STAFF REPORT

SUBJECT:	PRS 20-0949	PLANNING AREA:	University & Lutz
REQUEST:	Minor Modification to an Approved PD	SECTOR	Northwest
APPLICANT:	TSP Companies, Inc.		
Existing Zoning: PD 16-1338		Comp Plan Category: Res-1, Res-4 & Res-20

Figure 1: Area of Modification

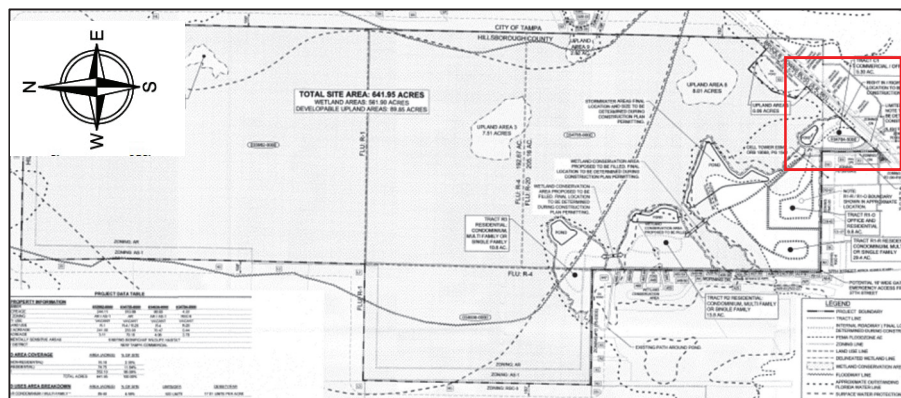
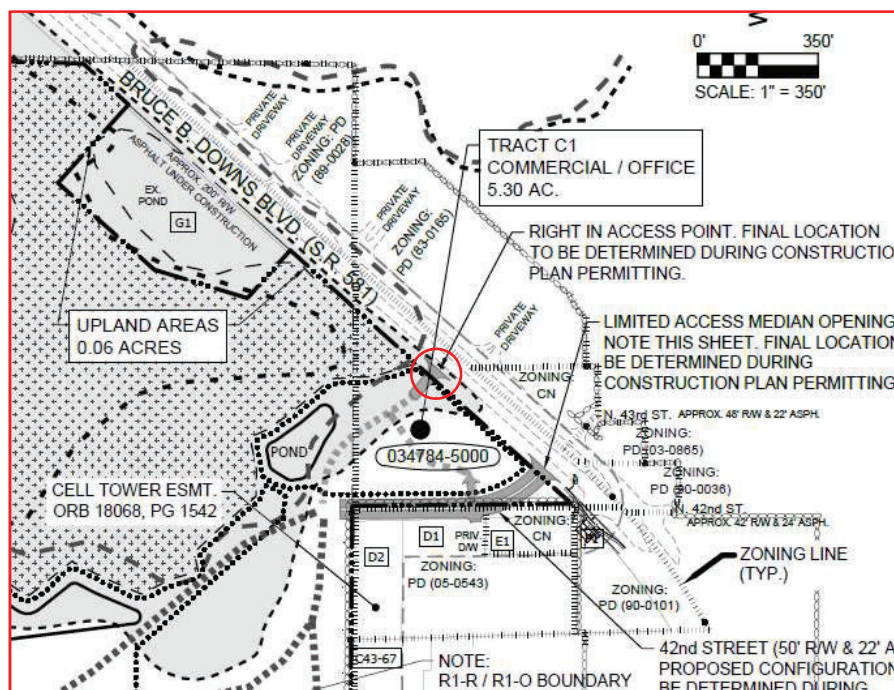
Change Tract C-1's access point from a right-in/right-out to right-in access point. Per the applicant's request, this change is requested due to the length of the turn lane required for the project's entrance, which will be extended across the frontage of Tract C-1 (Bruce B. Downs Blvd.) (see Figure 1). A right-out movement will create a conflict with vehicles entering the turn lane and create a safety issue. Additionally, a relocation of the turn lane, to avoid the conflict, would impact wetlands found to the northeast of Tract C-1.

11. The project shall be permitted the following access onto Bruce B. Downs Blvd.:
 - a. The easternmost access shall be restricted to right-in/~~right-out~~ turning movements; and,
